Attachment 4 Tree Retention Plan and Arborist Report
SUB14-01032

TREE RETENTION PLAN
AVALON EAST
PARCEL # 6743700370
CITY OF KIRKLAND WASHINGTON

From: Sandi Elder <elder.sandi@gmail.com>
Sent: Thursday, July 31, 2014 5:44 PM
To: Susan Lauinger
Subject: public comments on permits number SUB14-01033 and SUB14-01032
Attachments: Before removal of most prominent tree - picture 2.JPG; After tree removal.jpg; img011.jpg

From: Sam Elder <sam@samelderlaw.com>
Sent: Monday, August 11, 2014 3:24 PM
To: Susan Lauinger
Subject: Permit # SUB14-01032 and # SUB14-01033

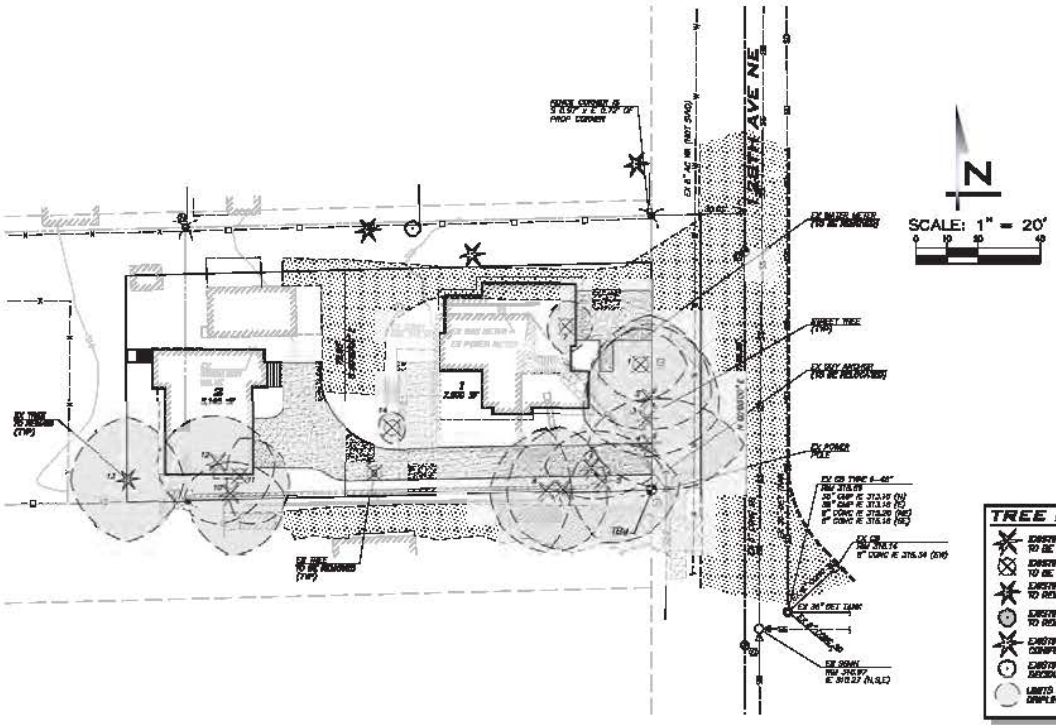
KCC 95.30 reiterates the City's policy in favor of "to retain as many viable trees as possible on a developing site." Locating the access road right through these Significant Trees violates KCC 95.30. The clear solution is to allow development of the property and allow an access road, but require Merit Homes to locate the access road on the north side of the Significant Trees.

This policy would be violated with the proposed location of the access road off 128th Ave. NE.

Merit Homes has not submitted a tree retention plan that complies with KCC 95.30. The proposed development calls for more than one tree retention plan component, thus KCC 95.30 requires that the more stringent tree retention plan requirements apply.

The proposed development by Merit Homes would cause these lots to fall below the 30 tree credit per acre threshold required by KCC 95.33. Merit Homes has failed to submit a Tree Retention Plan that addresses the tree credit issue.

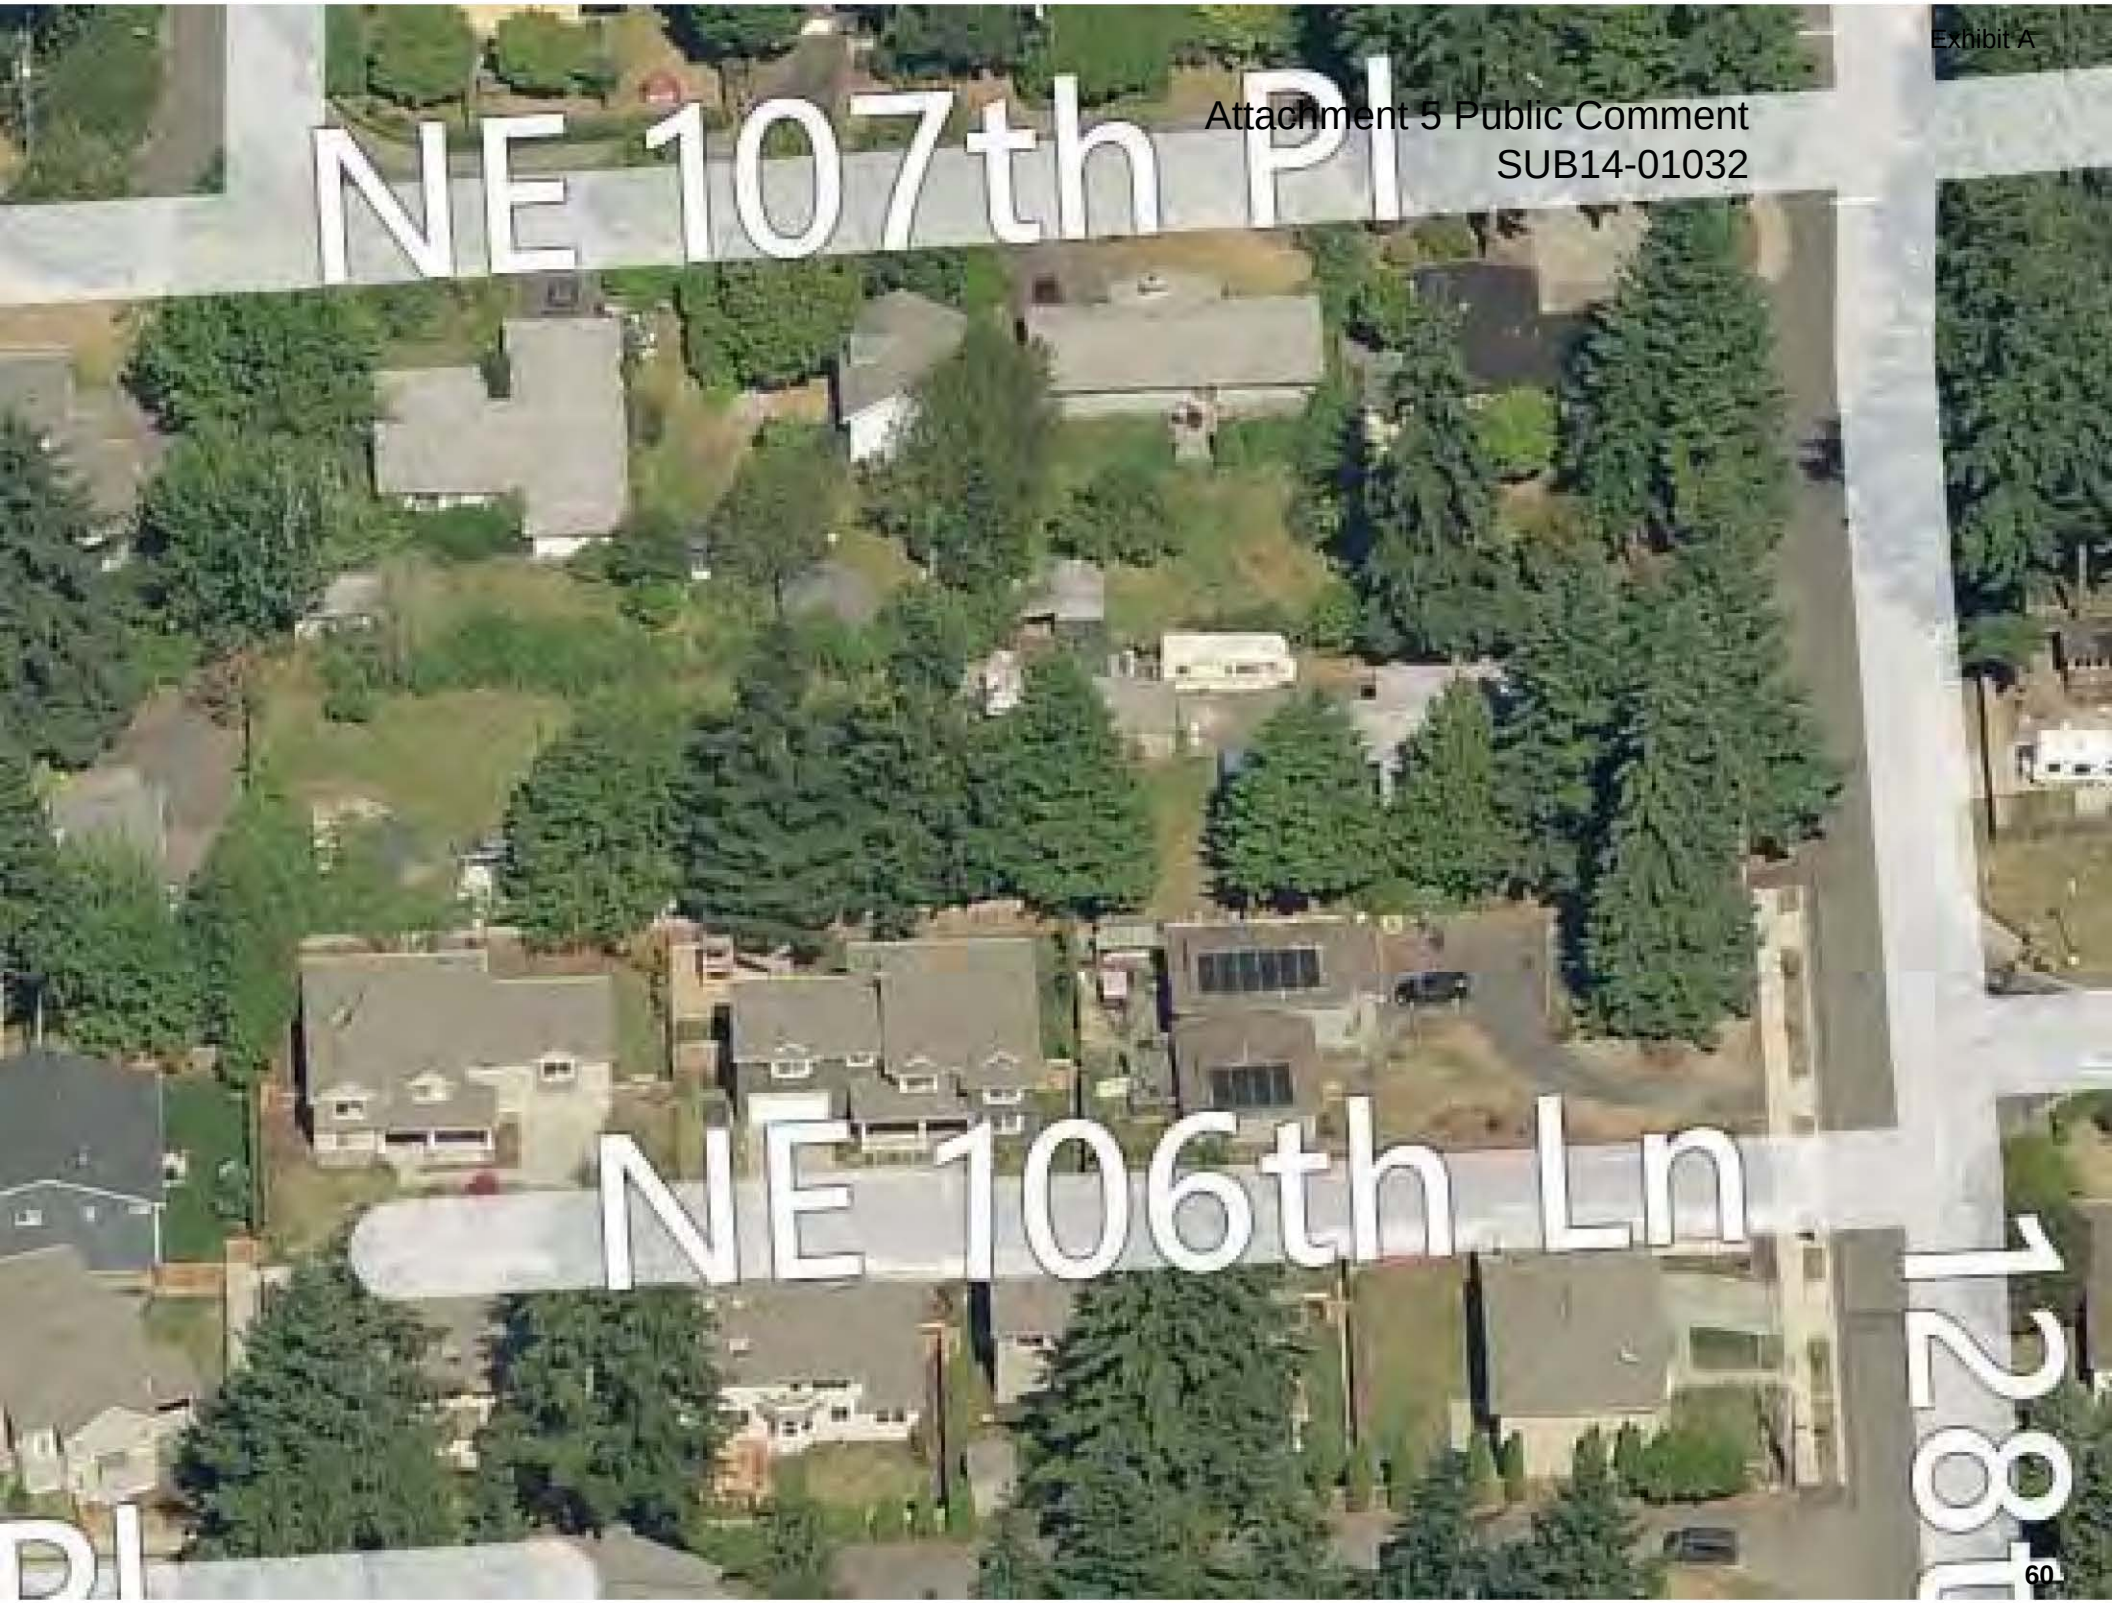
This stump is from another cut down tree that is not on the arborist report.
This tree was between #13 and #19 -- kind of hard for the arborist to miss it.
